# Wisconsin Department of Transportation

**Proposal #16: 7840-03-73, WISC 2024421**
**Black River Bridge B-10-0398**
**USH 10 - Greenwood**
**CTH G**
**Clark County**

This is Addendum No. 01, which provides for the following:

Addendum No. 01
ID 7840-03-73
Revised Sheet 77
August 2, 2024

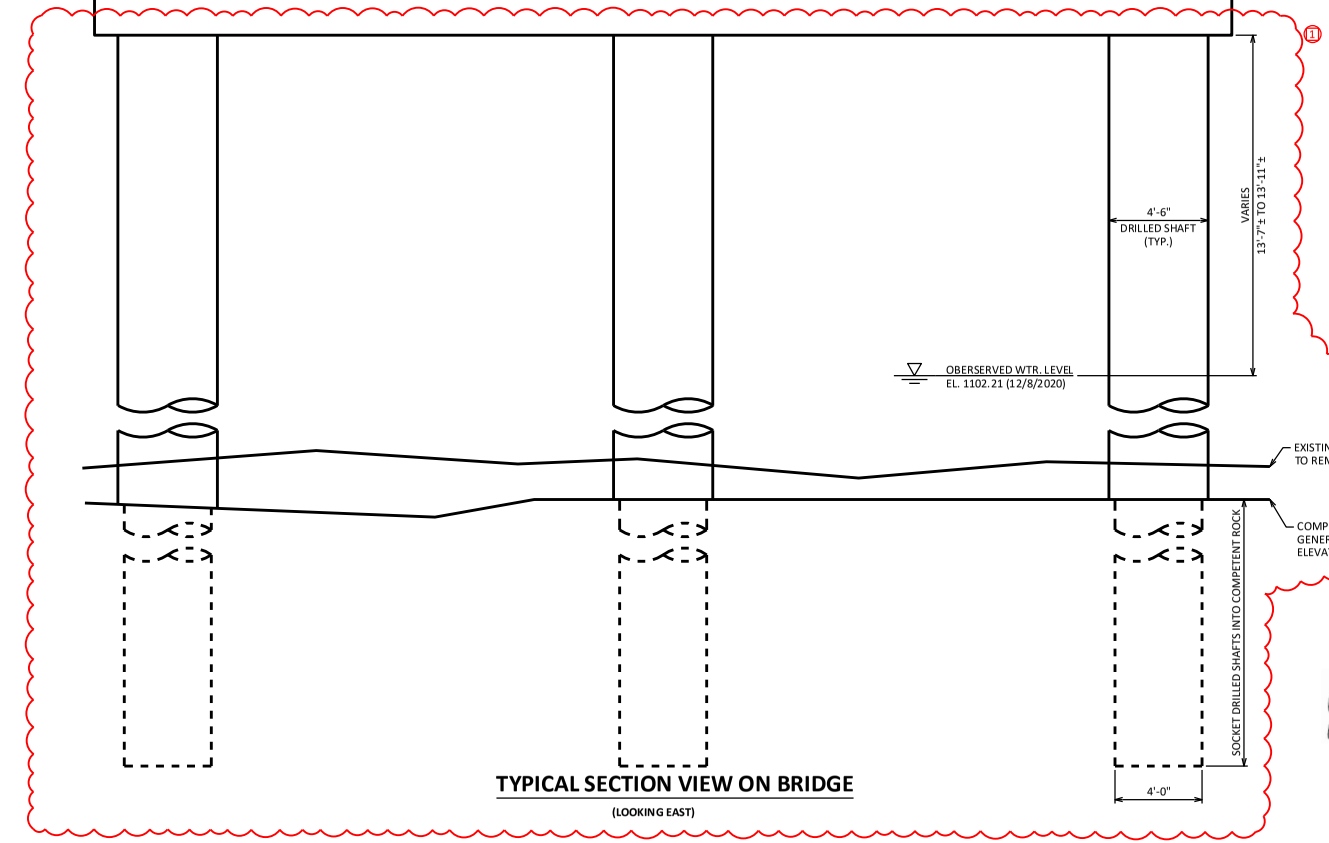
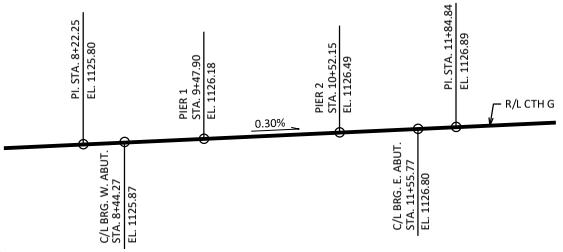
| **Revised** Plan Sheets | |
|---|---|
| 77 | Cross Section (Change column/drilled shaft diameter) |

Addendum No. 01
ID 7840-03-73
Revised Sheet 80
August 2, 2024

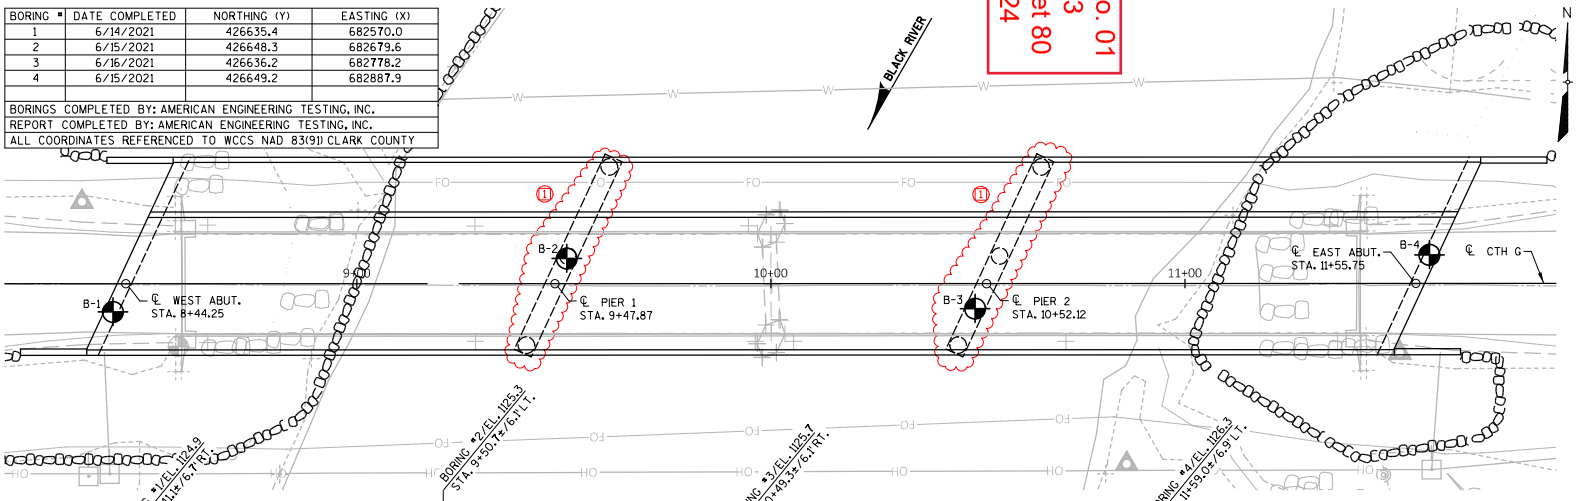
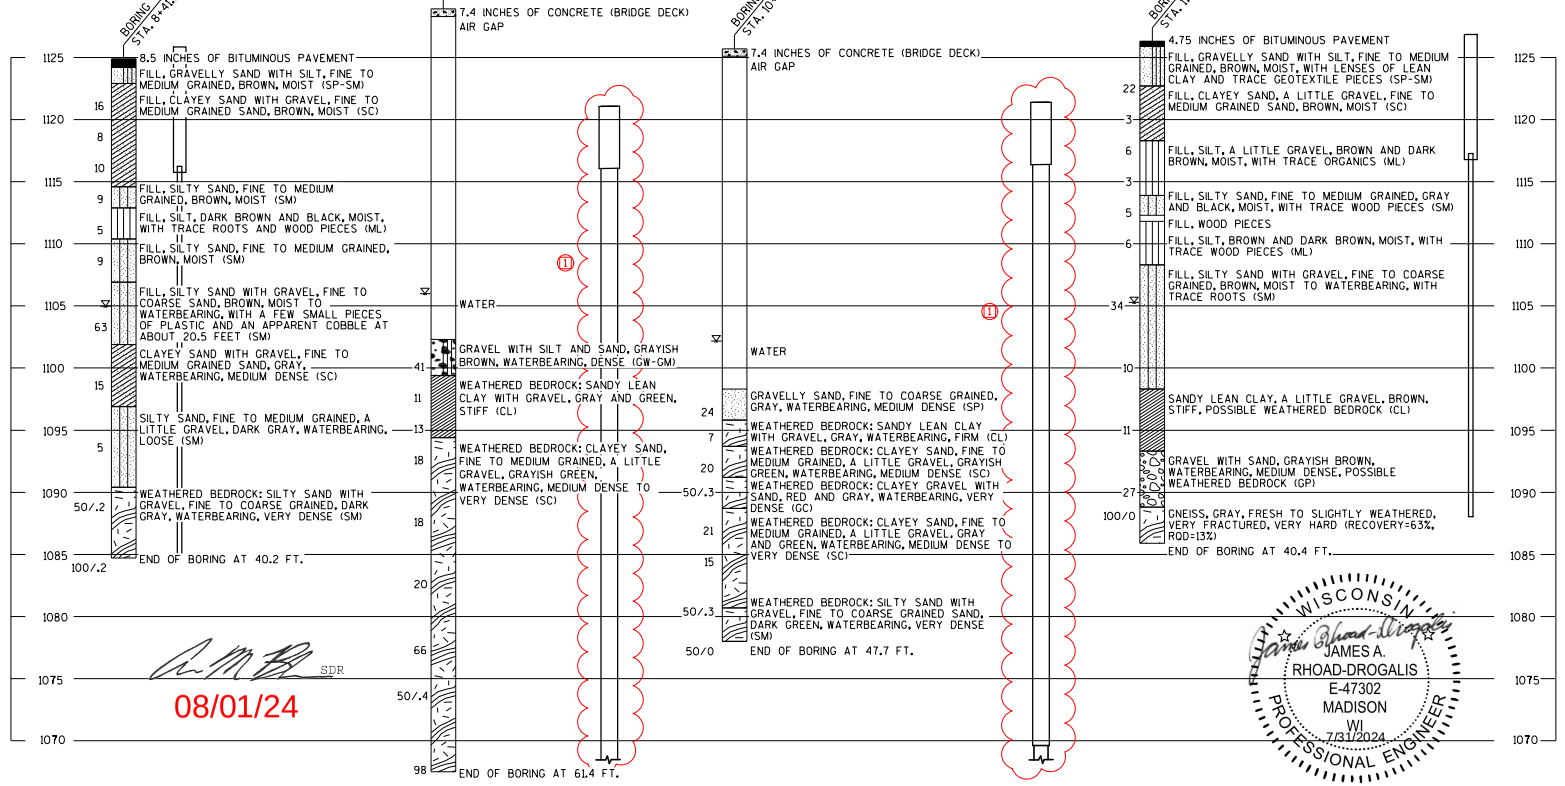
| **Revised** Plan Sheets | |
|---|---|
| 80 | Subsurface Exploration (Changed column/drilled shaft diameter) |

Addendum No. 01
ID 7840-03-73
Revised Sheet 81
August 2, 2024

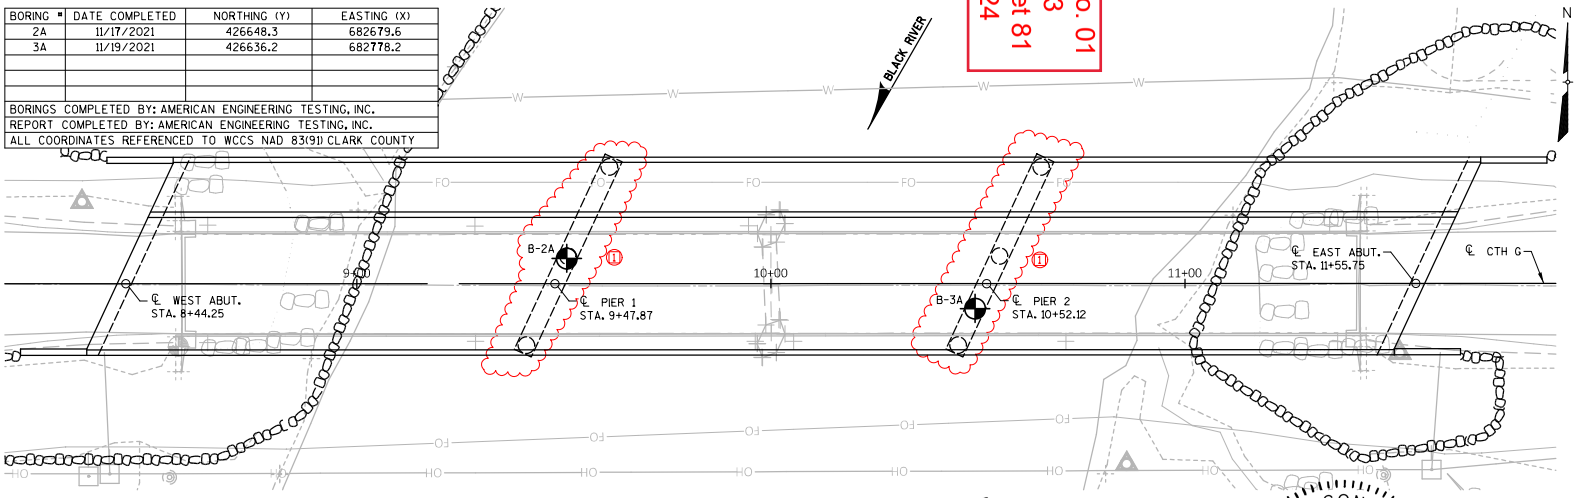
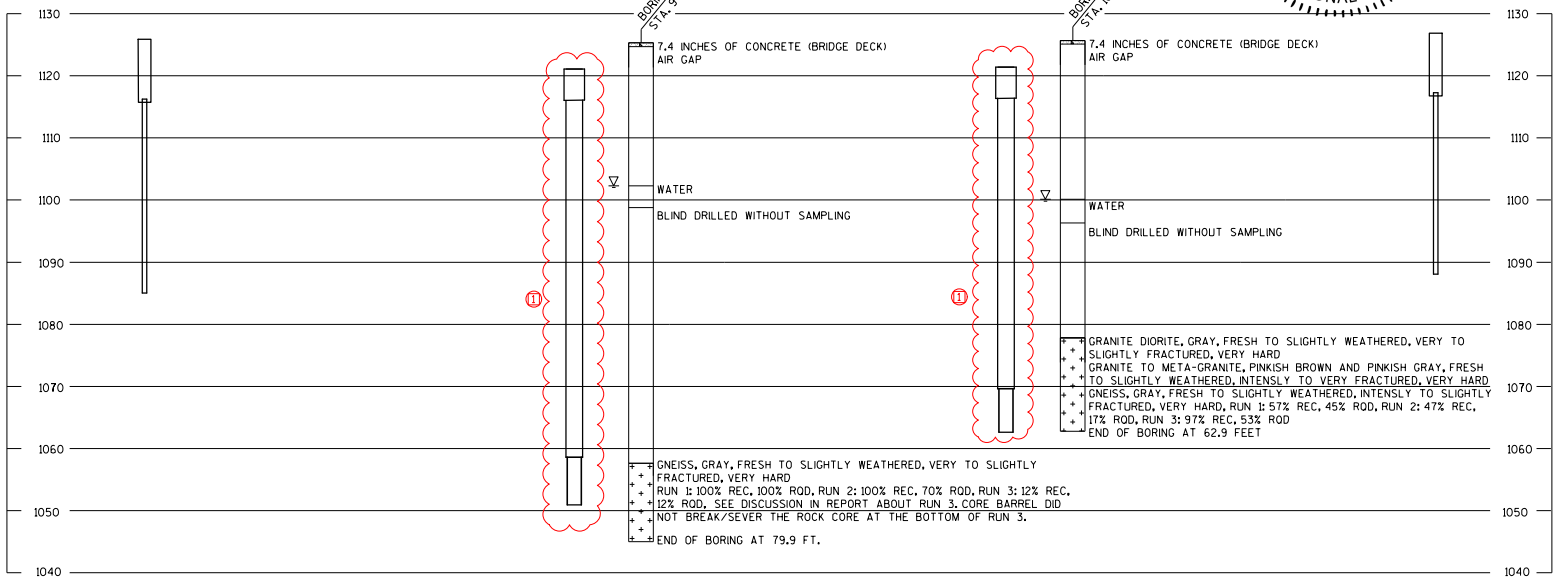
| **Revised** Plan Sheets | |
|---|---|
| 81 | Subsurface Exploration (Changed column/drilled shaft diameter) |

Addendum No. 01
ID 7840-03-73
Revised Sheet 93
August 2, 2024

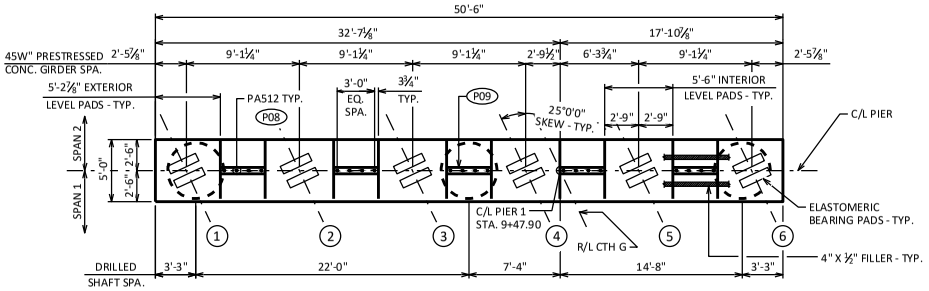
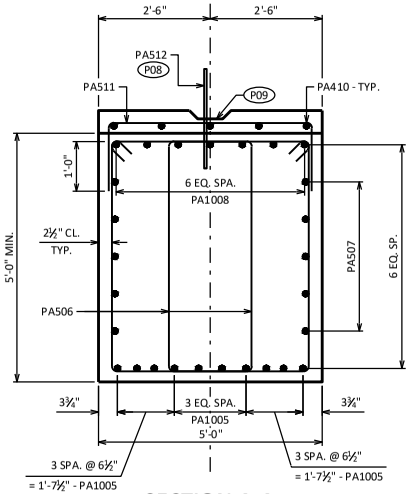
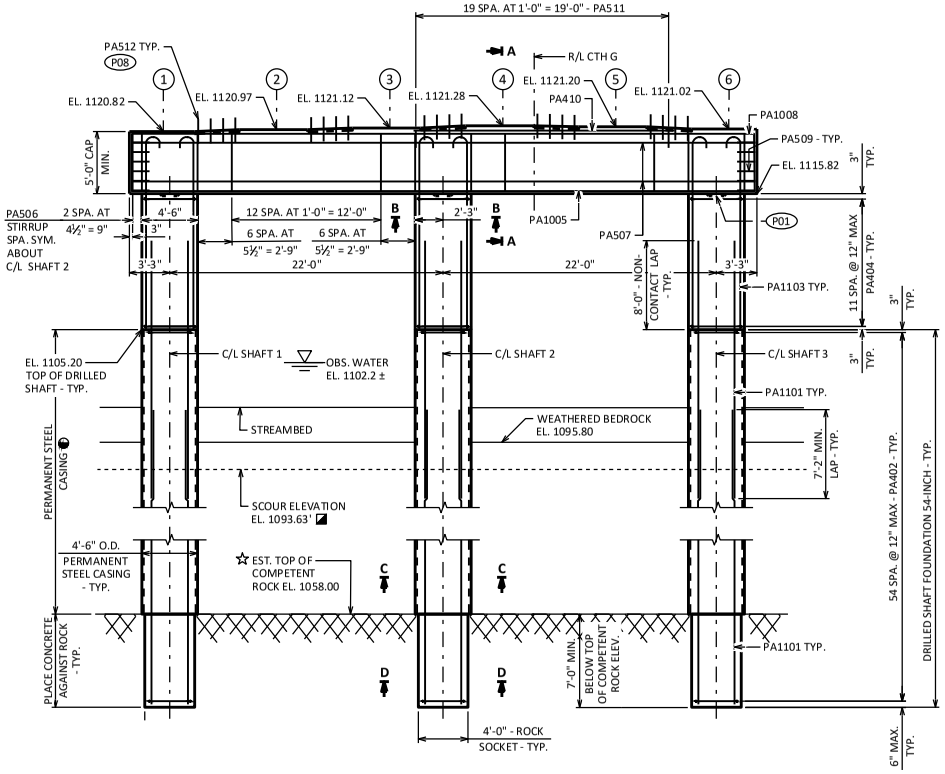
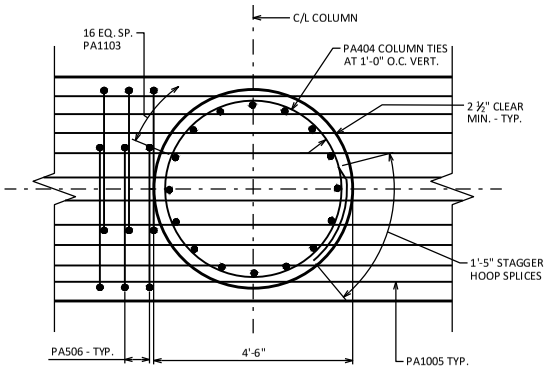
| **Revised** Plan Sheets | |
|---|---|
| 93 | Pier 1 (Drilled Shaft and Column Diameter) |

Addendum No. 01
ID 7840-03-73
Revised Sheet 94
August 2, 2024

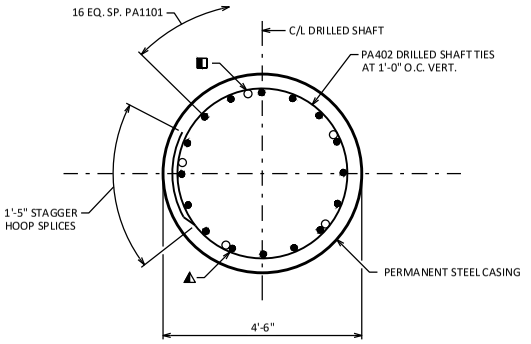
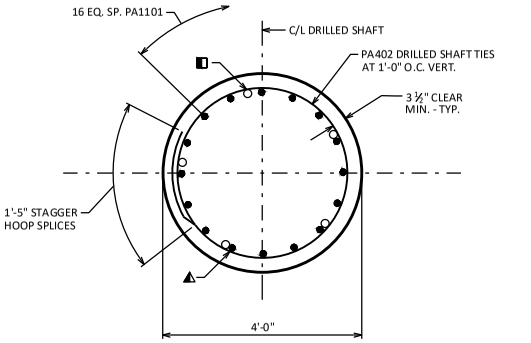
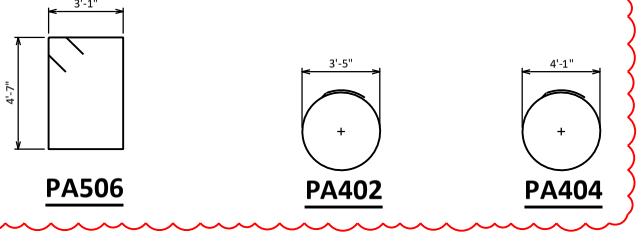
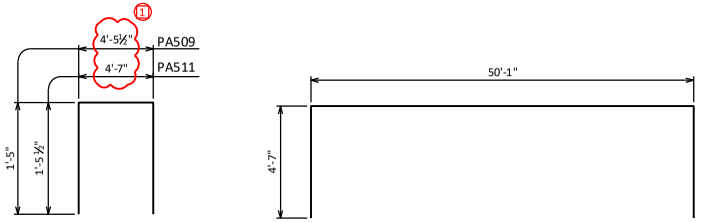
| **Revised** Plan Sheets | |
|---|---|
| 94 | Pier 1 Details (Updated Bill of Bars and Shaft Cross Section) |

◧ (5)-2" DIA. CSL TUBES FULL LENGTH OF SHAFT TIED INSIDE AND EVENLY SPACED AROUND THE PERIMETER OF REINFORCEMENT. EXTEND CSL TUBES 3'-0" ABOVE TOP OF SHAFT. REMOVE CSL TUBES DOWN TO TOP OF SHAFT AFTER TESTING IS COMPLETE.

Addendum No. 01
ID 7840-03-73
Revised Sheet 95
August 2, 2024

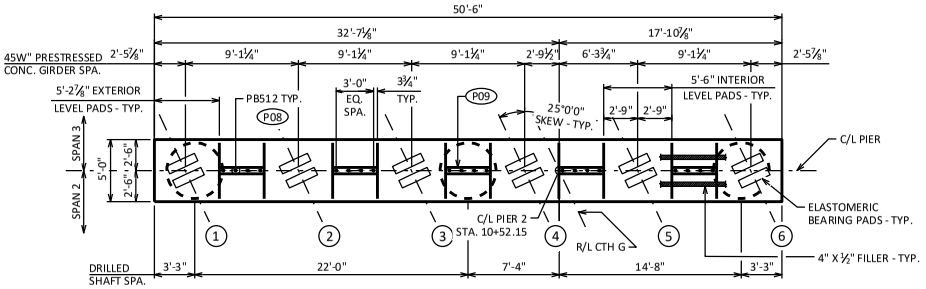
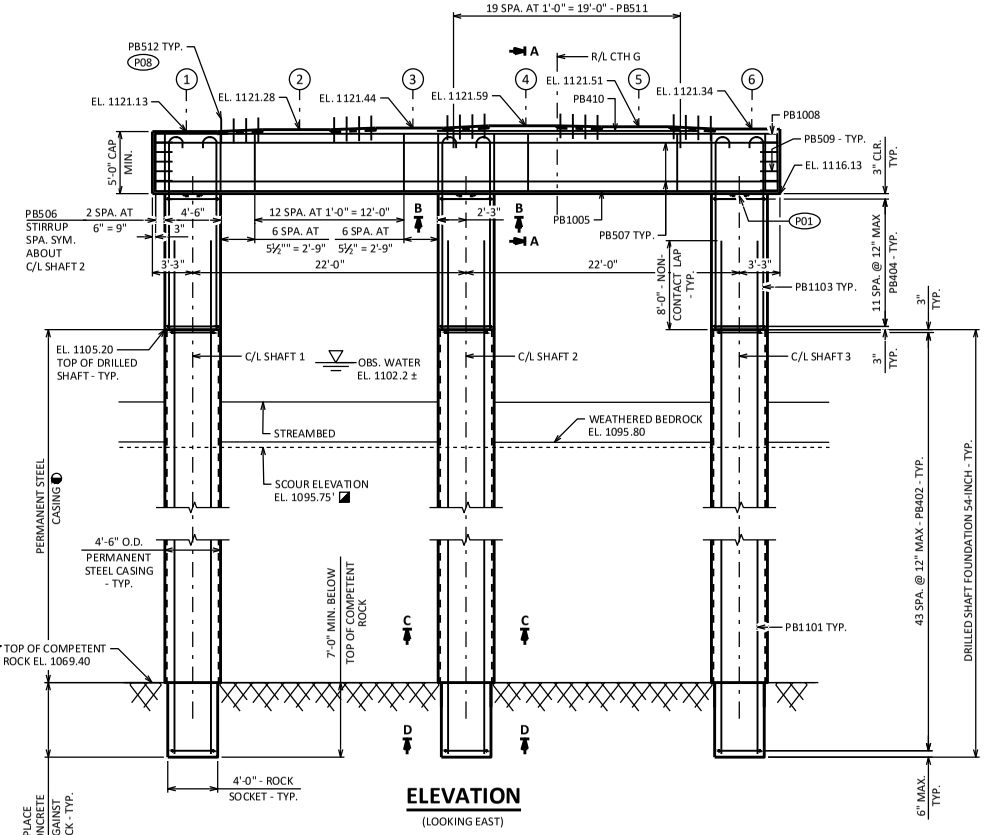
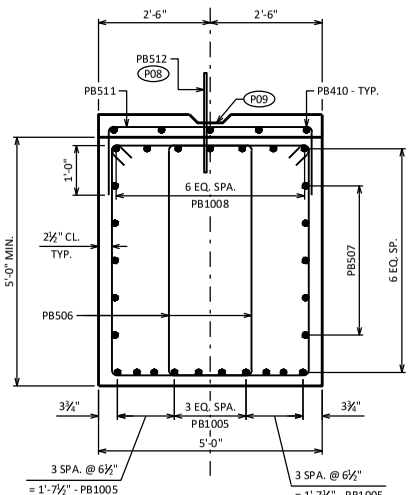
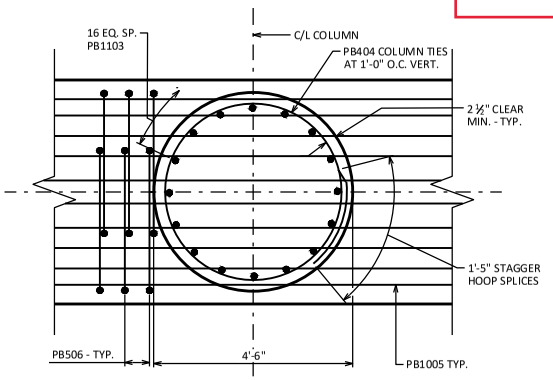
| **Revised** Plan Sheets | |
|---|---|
| 95 | Pier 2 (Drilled Shaft and Column Diameter) |

Addendum No. 01
ID 7840-03-73
Revised Sheet 96
August 2, 2024

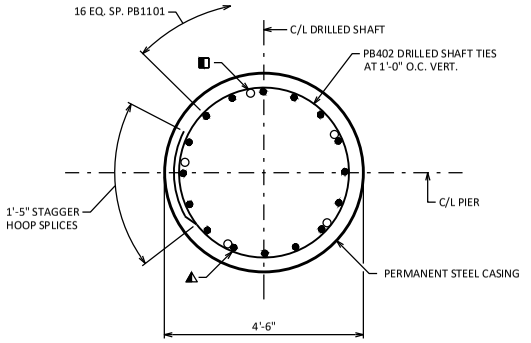
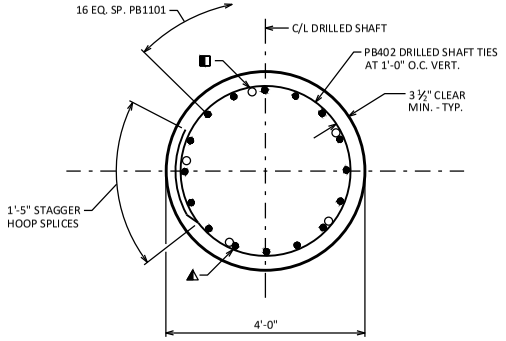
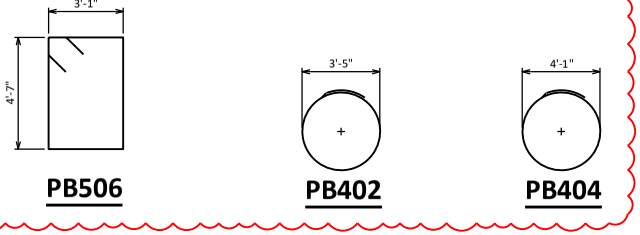
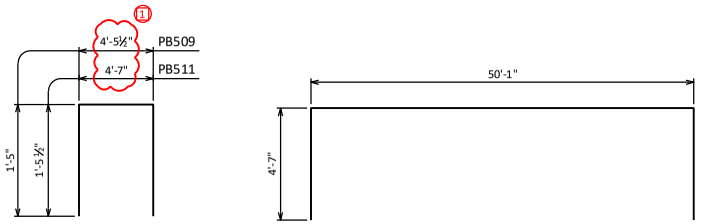
| **Revised** Plan Sheets | |
|---|---|
| 96 | Pier 2 Details (Updated Bill of Bars and Shaft Cross Section) |

◧ (5)-2" DIA. CSL TUBES FULL LENGTH OF SHAFT TIED INSIDE AND EVENLY SPACED AROUND THE PERIMETER OF REINFORCEMENT. EXTEND CSL TUBES 3'-0" ABOVE TOP OF SHAFT. REMOVE CSL TUBES DOWN TO TOP OF SHAFT AFTER TESTING IS COMPLETE.
